Sundry Print Report

Well Name: PGA UNIT 34 Well Location: T24N / R11W / SEC 34 / County or Parish/State: SAN

Type of Action: Plug and Abandonment

CONDITIONS OF APPROVAL

Planned P & A Wellbore Schematic

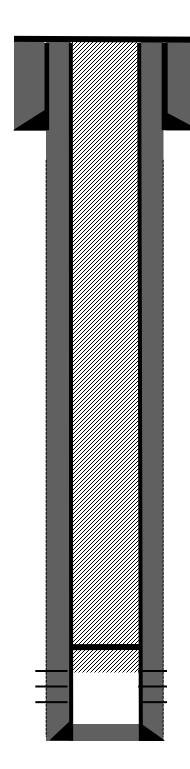
Set 5 $\frac{1}{2}$ " CR @ 582'. Squeeze 20 sks, 23 Cu.ft cement to cover the Pictured cliffs top below the retainer.

Plug I, Inside 5 ½" casing, Cement Retainer at 582', 90 sks, 103.5 Cu.ft, Pictured Cliffs-Fruitland-Kirtland-Surface, 0'-632'.

- 1. Plugging operations authorized are subject to the attached "General Requirements for Permanent Abandonment of Wells on Federal and Indian Lease."
- 2. The following modifications to your plugging program are to be made: a. Complete wellbore fill up proposal. No changes to the procedure.
- 3. <u>Notification:</u> Farmington Office is to be notified at least 24 hours before the plugging operations commence at (505) 564 7750.

Complete wellbore fill up proposal. No changes to the procedure.
